Subject: FCA US LLC Customer Satisfaction Notification Report (CSNR) S74-C.

## FCA US LLC Customer Satisfaction Notification Report (CSNR) S74-C

## **Customer Satisfaction Notification S74 Engine Oil Viscosity**

**Figure 6 – Engine Oil Fill Cap**

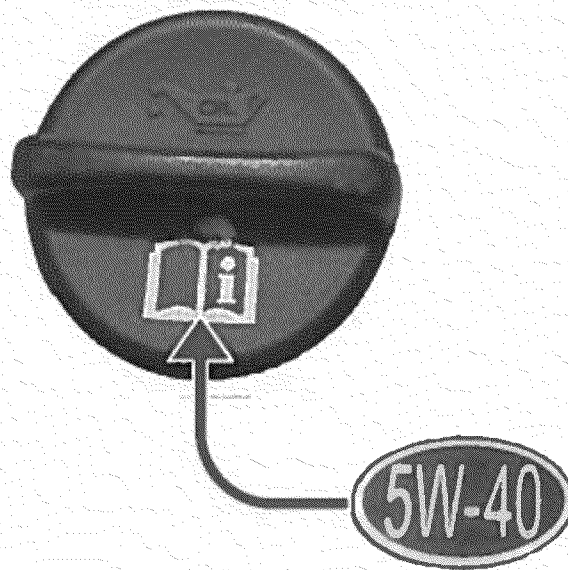
23. Apply engine oil viscosity rating sticker as shown in (Figure 6).

24. Install the oil fill cap with the new 5W-40 sticker firmly attached (Figure 6).
